**56 Rutledge Street Eastwood**

**Construction of a two storey child care centre with basement car parking and a capacity for 70 children**

**City of Ryde  
Local Planning Panel Report**

| <b>DA Number</b>                         | LDA2024/0195   |

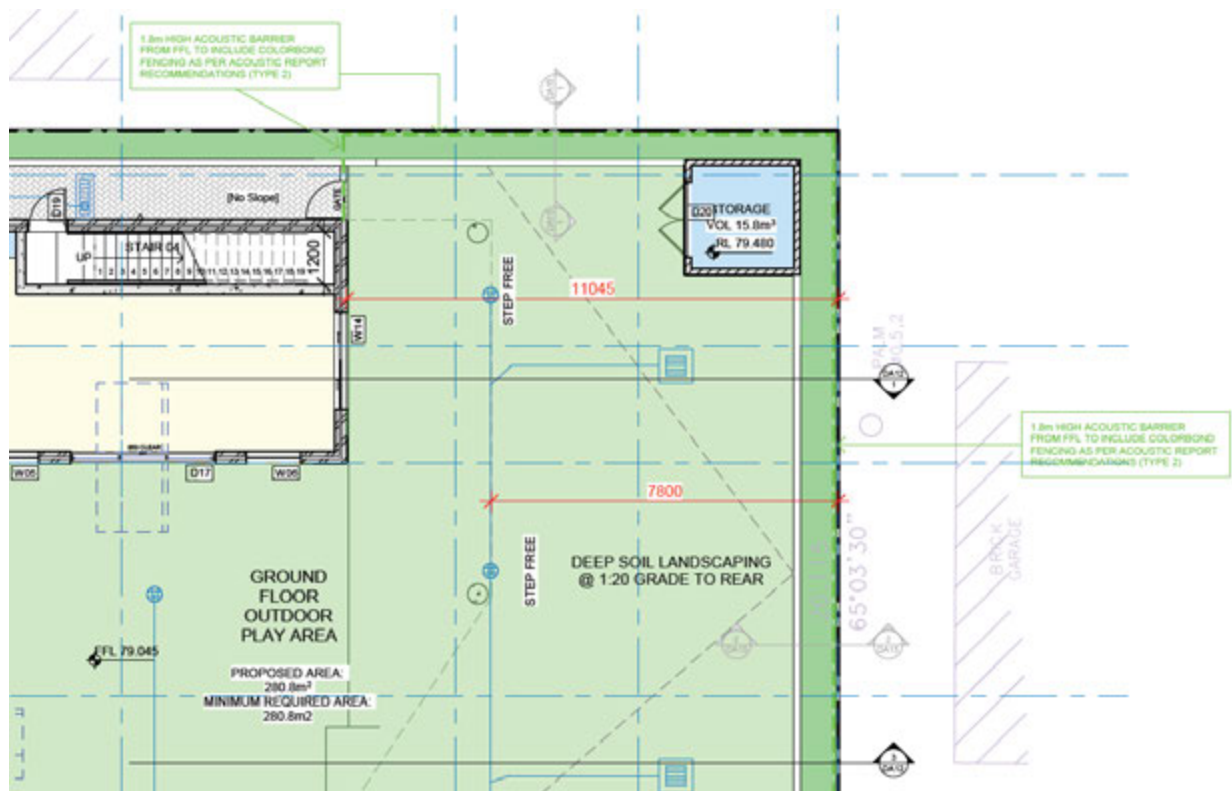
1. The acoustic consultant/ applicant must clarify the permissible outdoor play scenarios under Section 8.1.2 of the Acoustic Report.

The note under Section 8.1.2 heading of the Acoustic Report suggests that 2-3 year olds are designated to use the **first floor** outdoor play area only, whilst the second

bullet point in the same section states that 2-3 year olds (up to 20 children) will be utilising the **ground floor** outdoor play area.

The Acoustic Report and Plan of Management should be updated to ensure consistency.

1 ACOUSTIC BARRIER TYPE 2 - EASTERN BDRY  
1 : 20

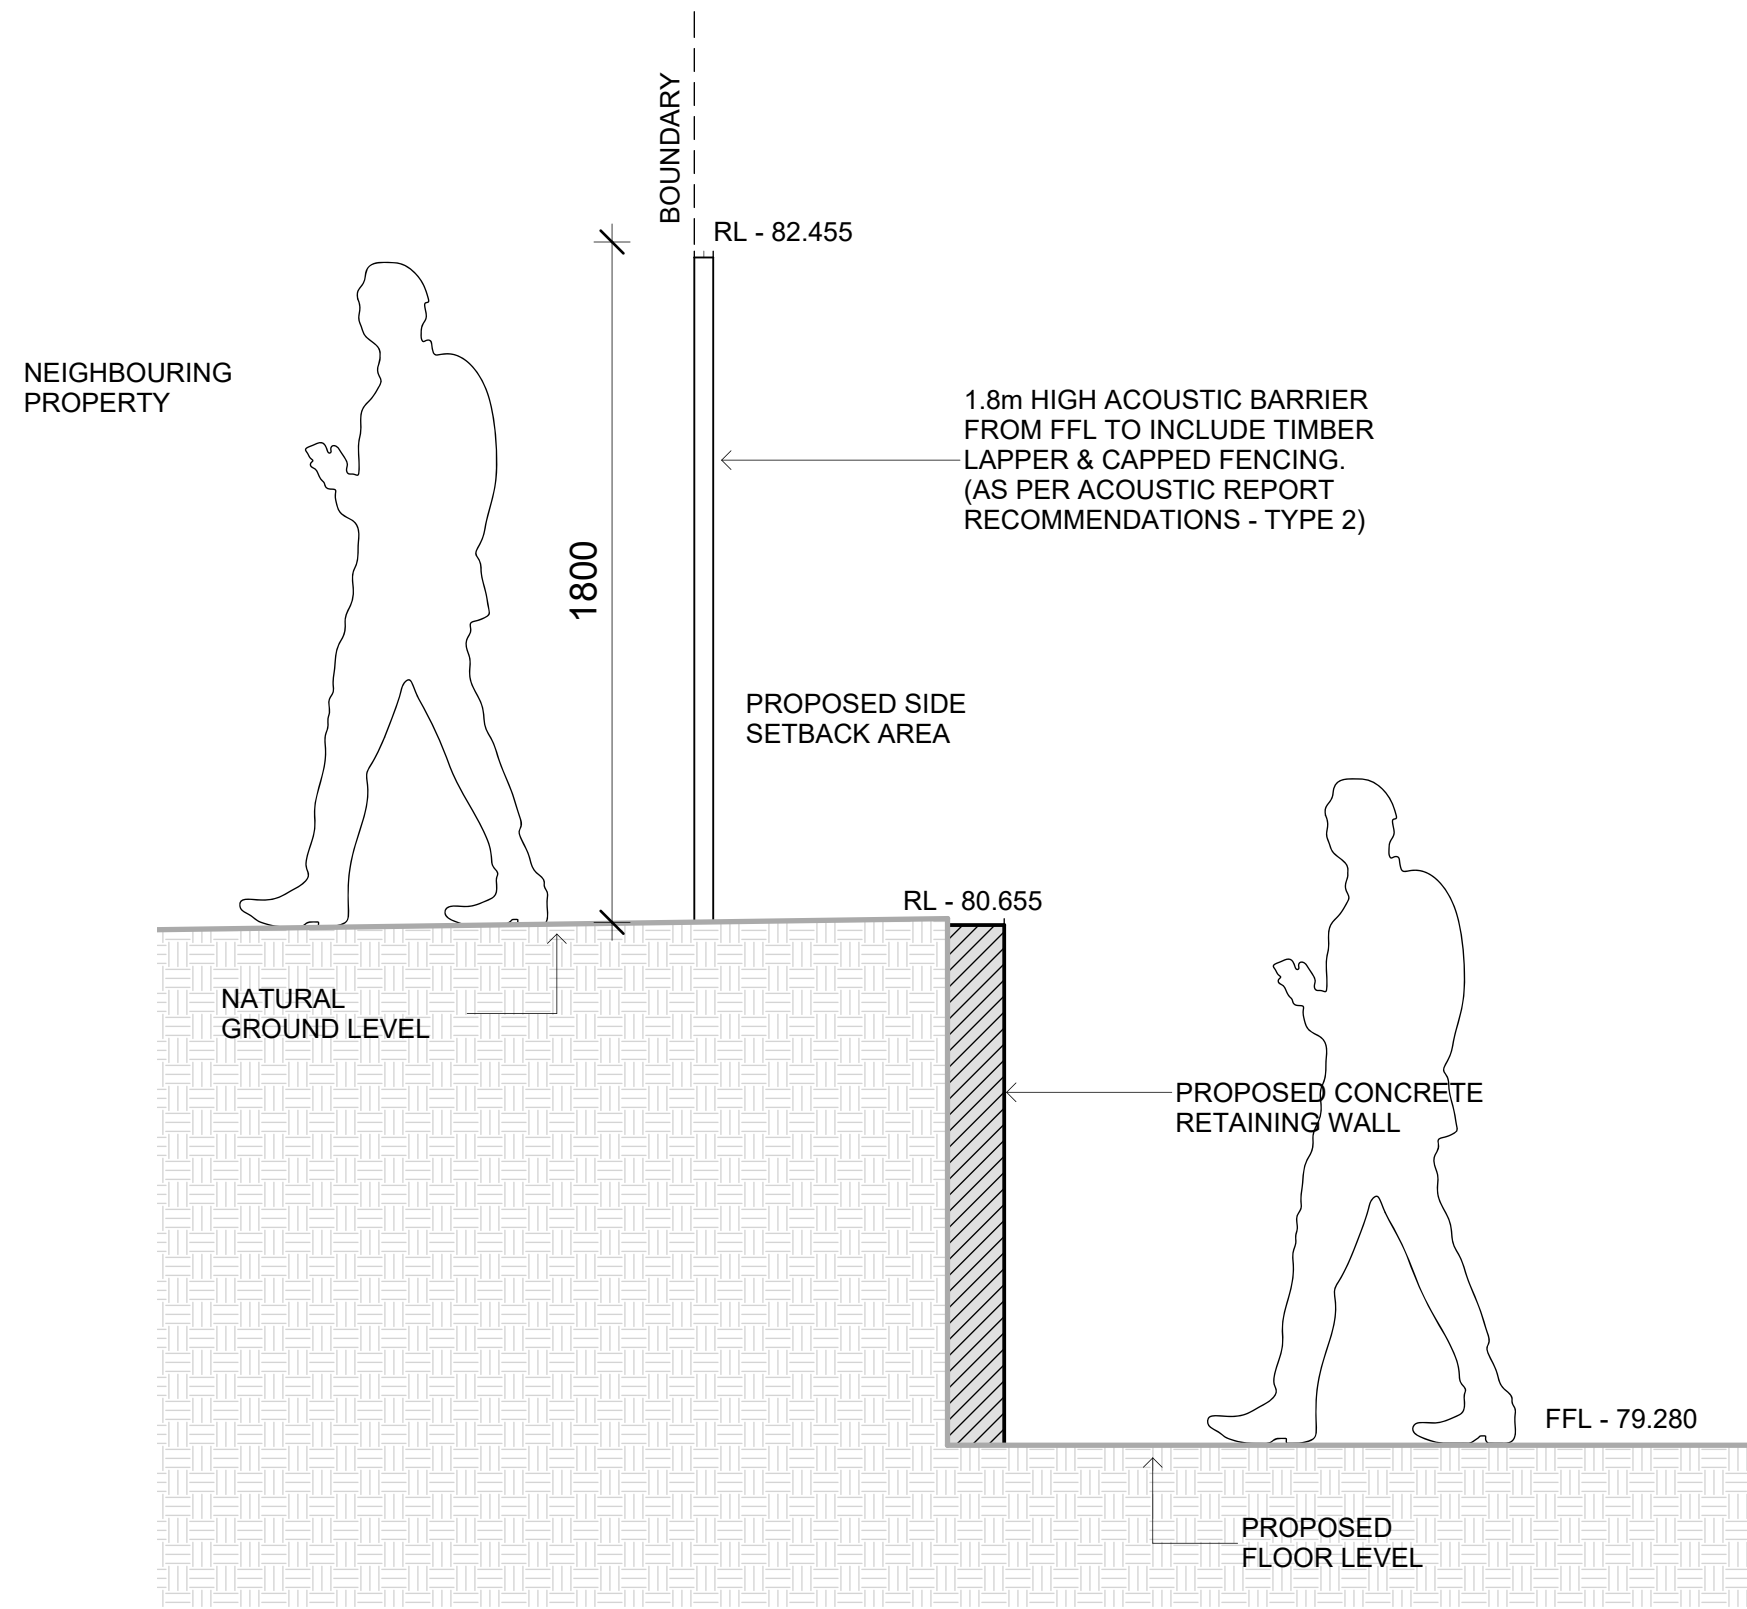
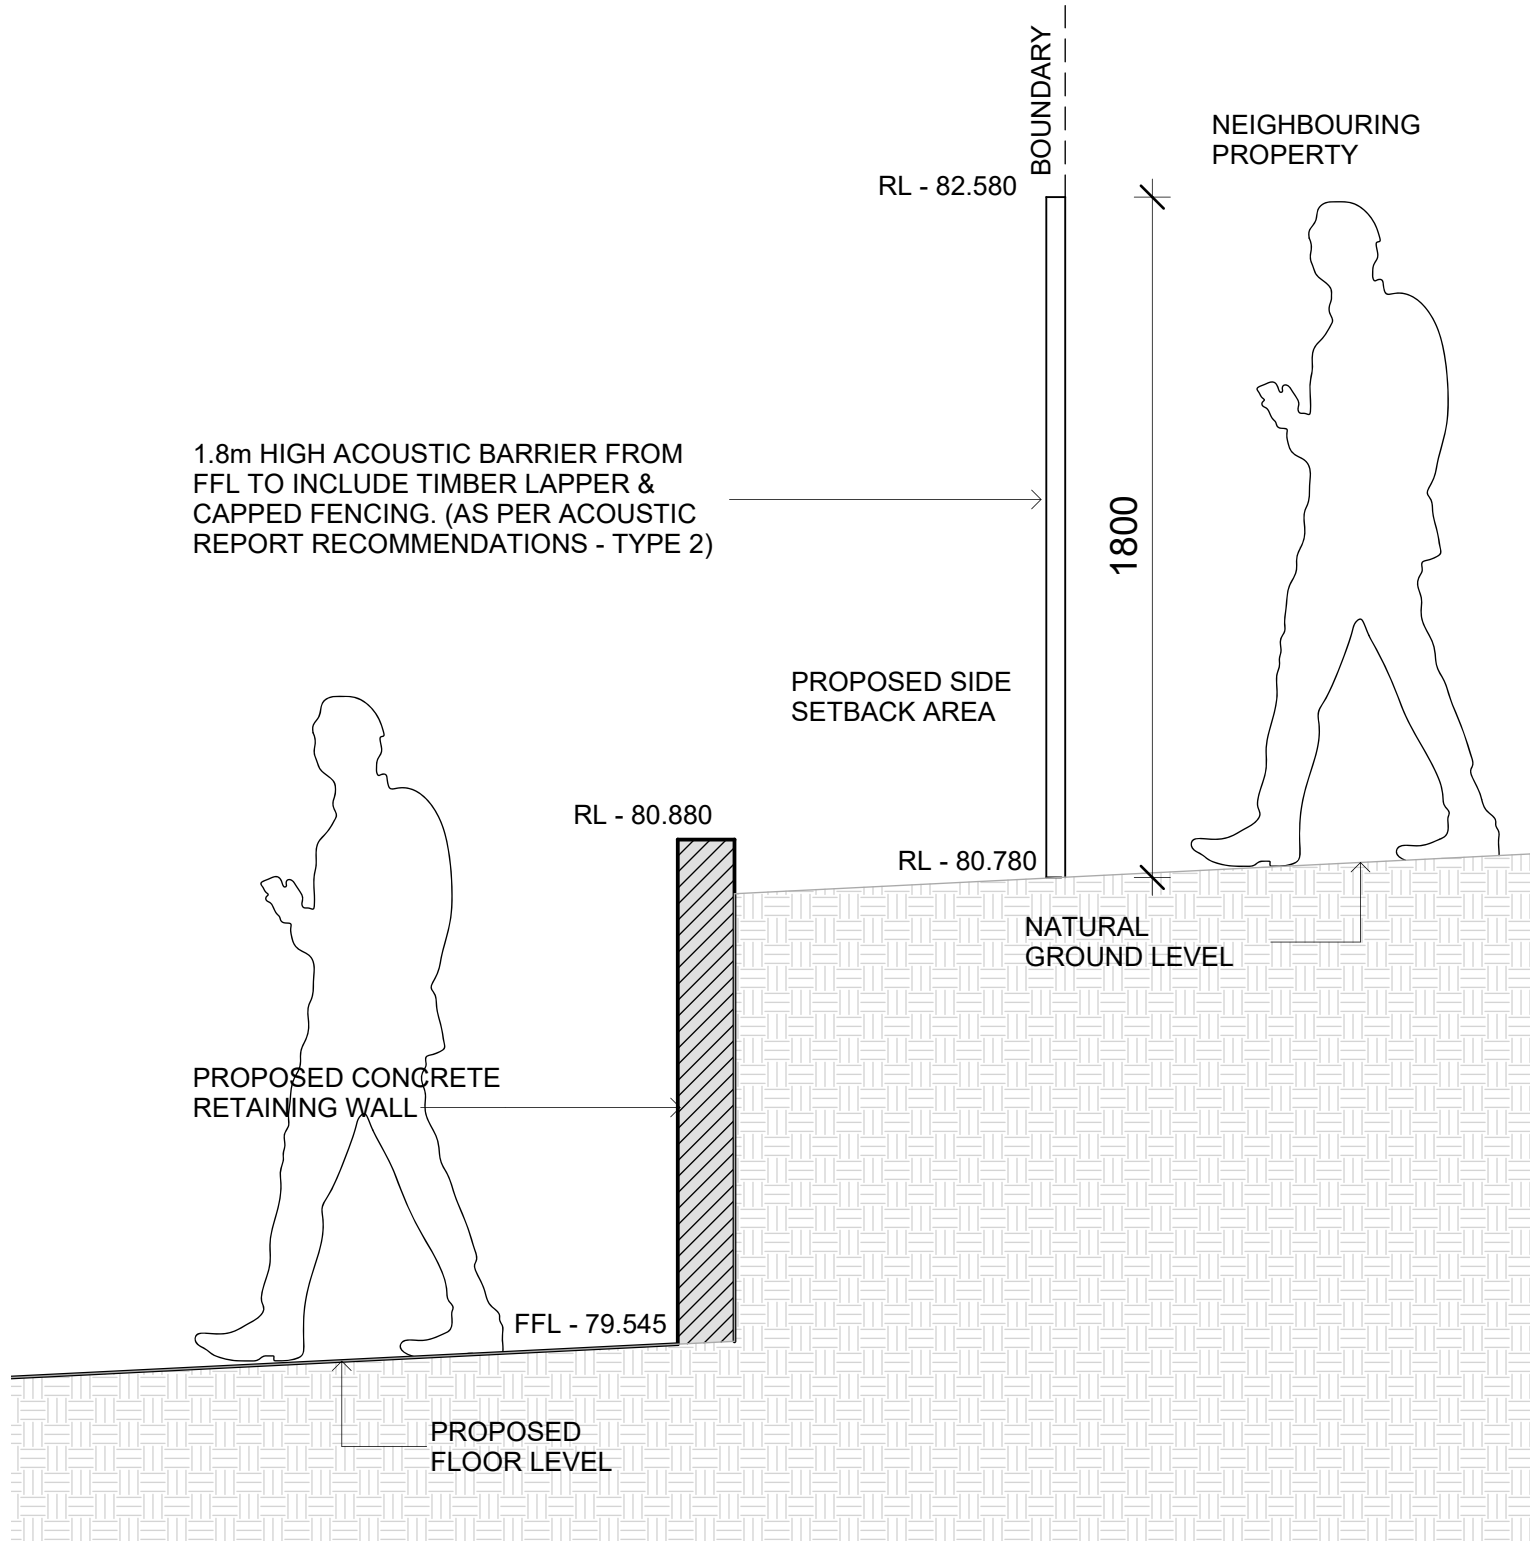
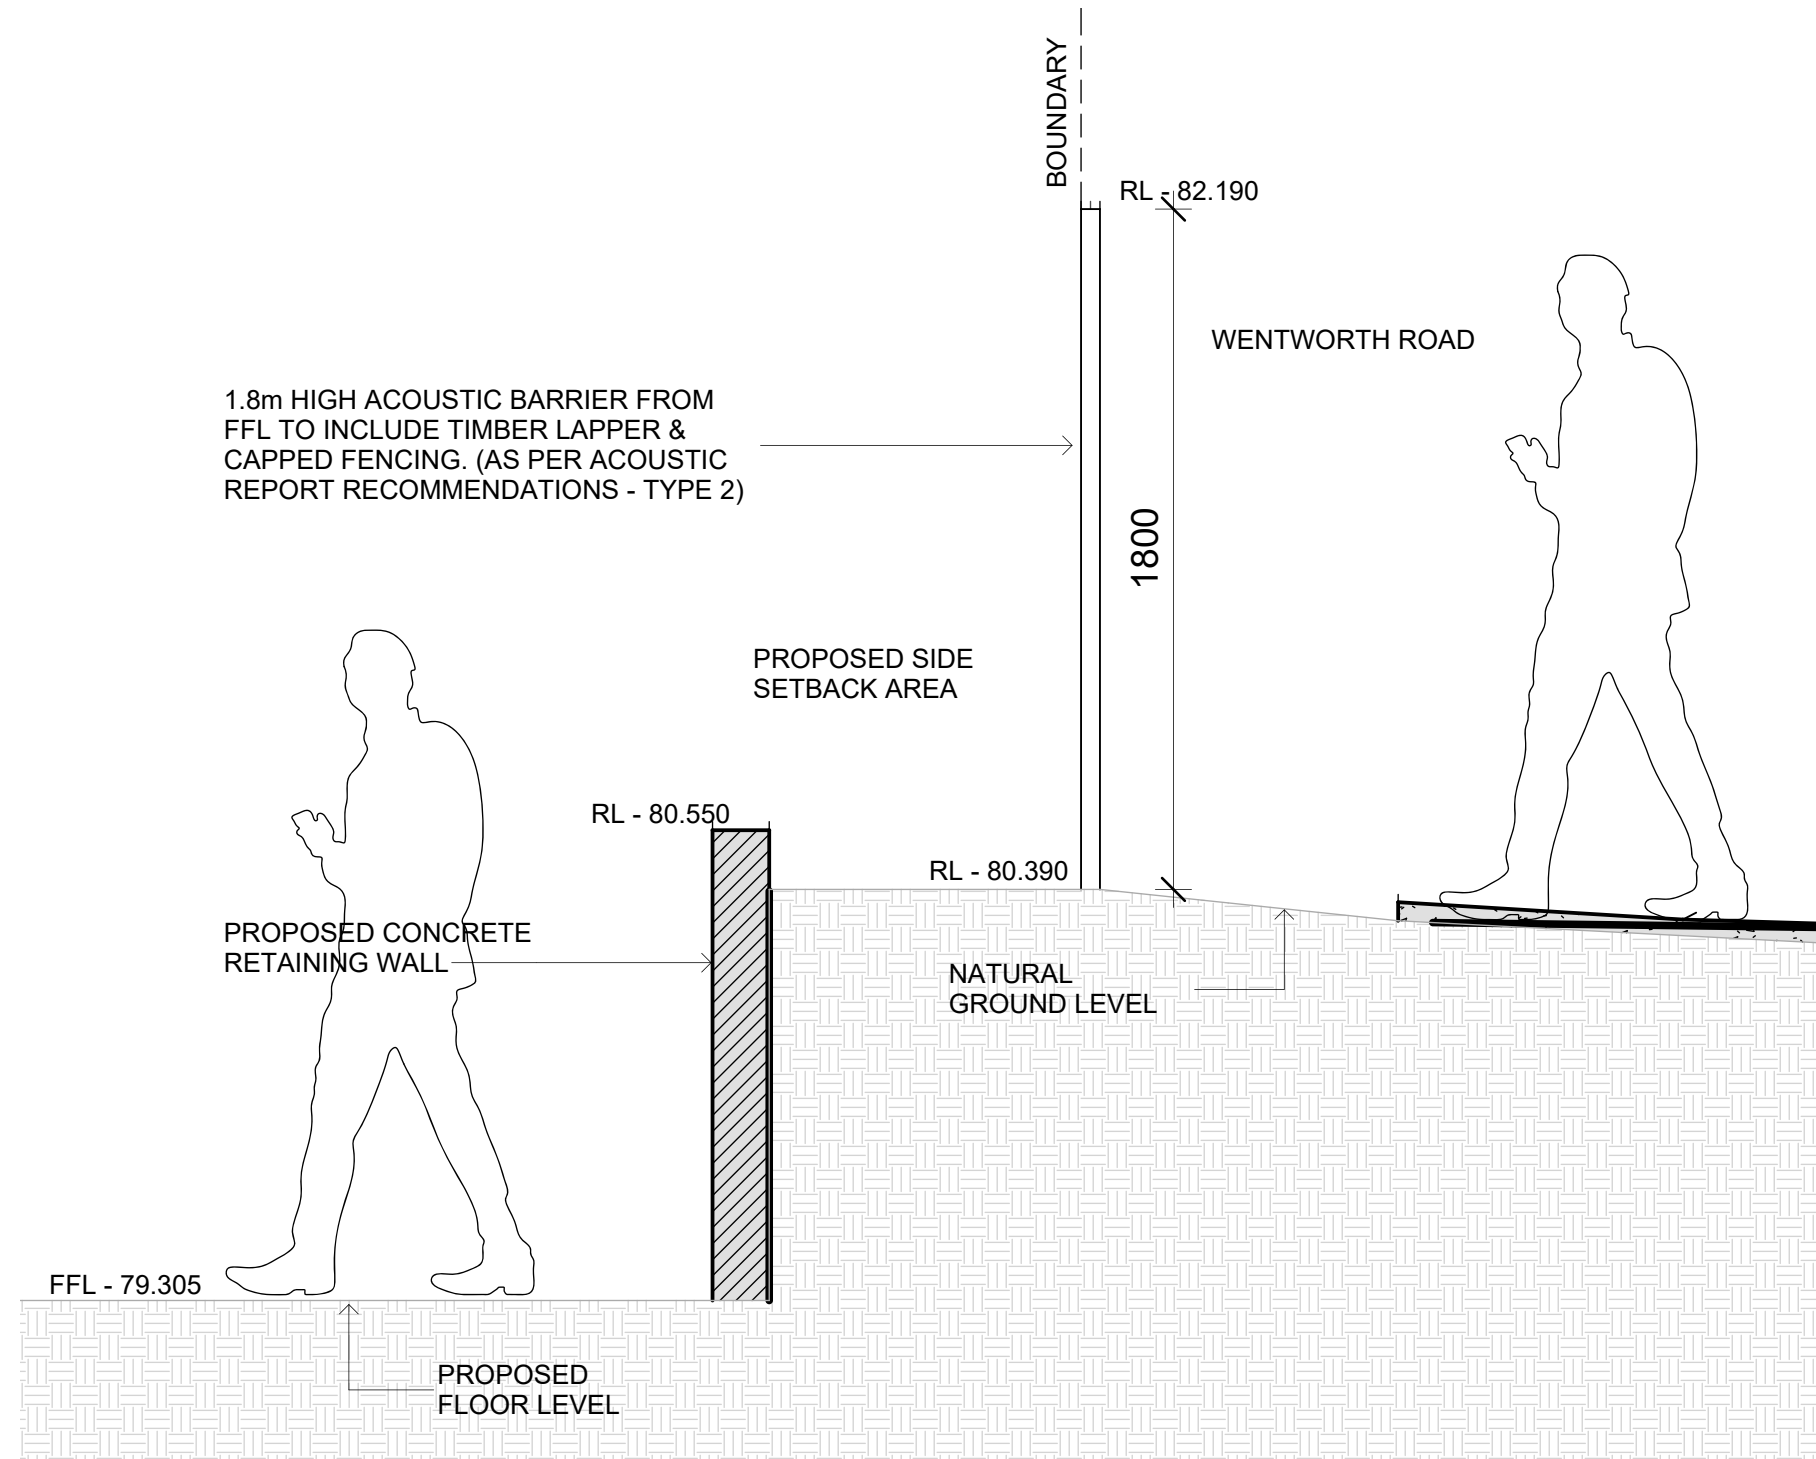
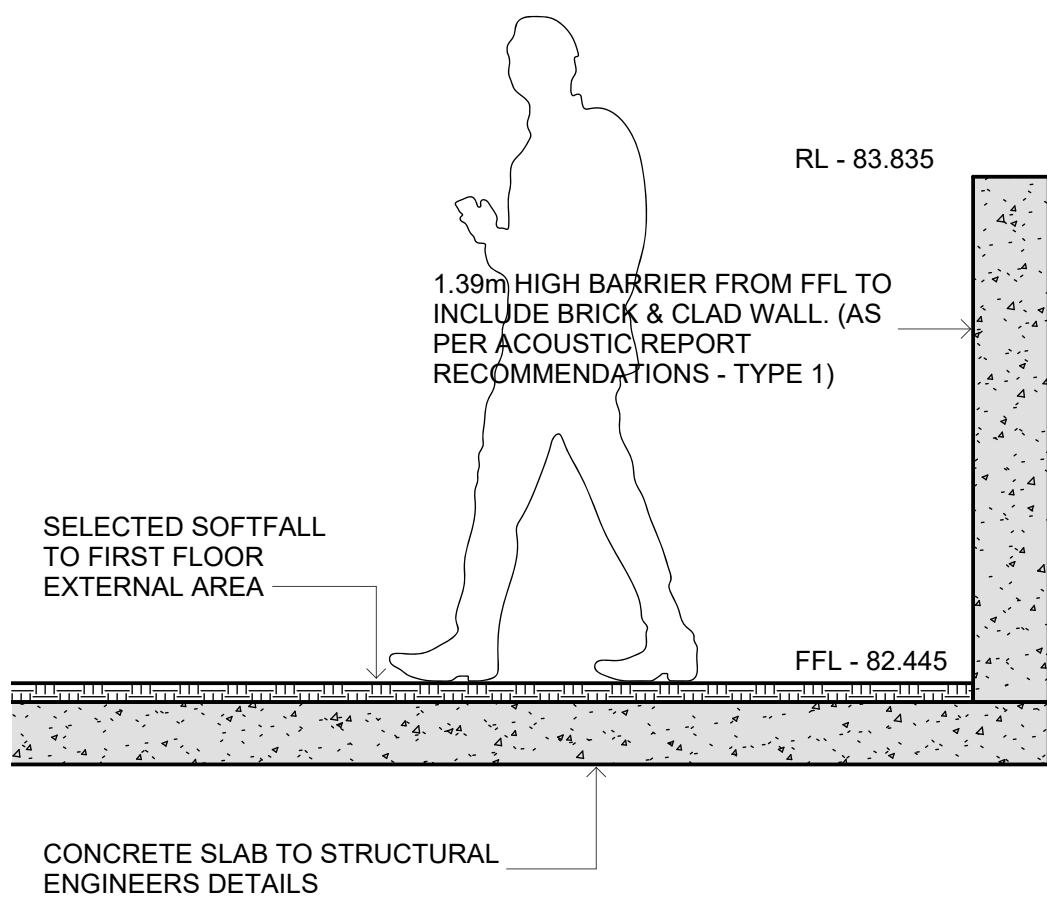
As previously outlined, there are deficiencies in the acoustic report in relation to the noise impact of the classified road on the cot room and the architectural plans do not

reflect the correct sound barrier fence materials and height recommended in the acoustic report.

Amenity to neighbours is considered to be unsatisfactory. The architectural plans do not reflect the recommendations of the acoustic report in relation to the sound barrier fence materials and heights recommended in the acoustic report. Further, the acoustic report does not clearly clarify the permissible outdoor play scenarios under Section 8.1.2 of the report. Further, there are concerns in relation to the suitability of the site in relation to air quality.
